STAFF RECOMMENDATION 200 Elmington Avenue October 16, 2019

Application: New Construction – Addition and Outbuilding
District: Elmington Place Neighborhood Conservation Zoning Overlay
Council District: 25
Base Zoning: RS7.5
Map and Parcel Number: 104 10 0 016.00
Applicant: Van Pond, architect
Project Lead: Jenny Warren, jenny.warren@nashville.gov

<p>Description of Project: Application for construction of an addition and an outbuilding.</p> <p>Recommendation Summary: Staff recommends approval with the conditions that:</p> <ol style="list-style-type: none">1. Staff shall approve the final roofing color, column material, doors, garage doors, windows and driveway material, prior to purchase and installation; and2. The dormers on the garage shall not exceed fifty percent (50%) of the roof plane; <p>finding that the project meets Section II.B of the <i>Elmington Place Neighborhood Conservation District: Handbook and Design Guidelines</i>.</p>	<p>Attachments</p> <p>A: Photographs B: Site Plan C: Elevations</p>
--	---

Figure 4: Proposed rear elevation

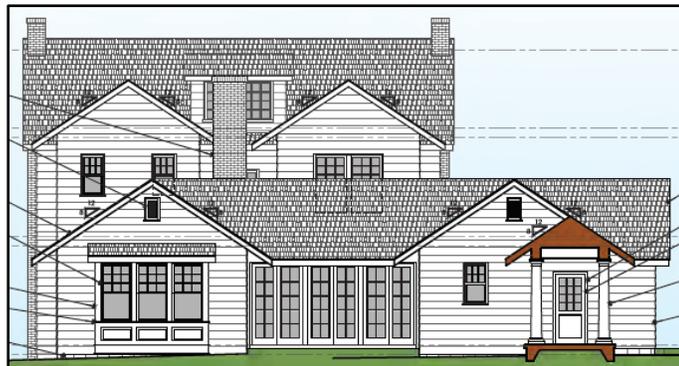
Roof form: The addition includes two rear-facing gabled sections that flank the existing rear dormer. These sections are two stories tall and tie into the existing side gabled roof about four feet (4') below the ridge. They have an 8/12 slope to match the historic gabled roof form. The existing rear shed dormer will remain.

The one-story portion of the addition which incorporates both side and rear gables which will continue the 8/12 slope.

Staff finds that the project meets section II.B.1.e for roof shape.

Figures 6 & 7: Outbuilding, house facing elevation and street-facing elevation

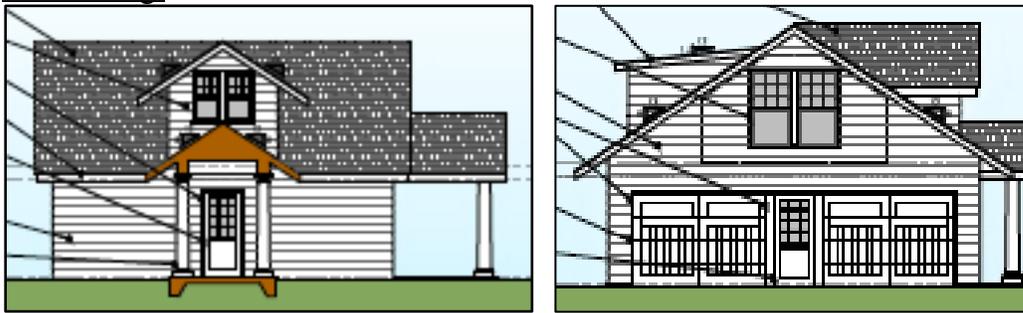
The proposed ridge height will be approximately twenty feet (20') tall, which is less than the thirty-three foot (33') tall house and less than the twenty-five foot (25') maximum. The eave heights will be about eight feet (8'), which meets the guidelines.

The primary roof form is gabled, which is appropriate. There is a shed dormer facing the rear property line and a gabled dormer facing the back of the house. Both are inset two feet (2') from the wall below and occupy no more than fifty percent (50%) of the roof plane, as per the guidelines (Note that there is an inconsistency and that in plan, the east elevation dormer is larger than 50% - the applicant has agreed to shrink this dormer to meet the guidelines.) Staff finds that with the east elevation dormer shrunk to cover no more than fifty percent (50%) of the roof plane, the proposal meets Section II.B.1.h of the design guidelines for roof shape.

The applicant proposes to use beveled lap siding with a 9" reveal to match the siding on the historic house. This is appropriate. The remaining proposed materials are largely compatible with the materials found in the historic context. With staff's final approval of the roofing color, column material, windows, doors and garage doors, staff finds that the materials meet the design guidelines.

1. Staff shall approve the final roofing color, column material, doors, garage doors, windows and driveway material, prior to purchase and installation; and
2. The dormers on the garage shall not exceed fifty percent (50%) of the roof plane;
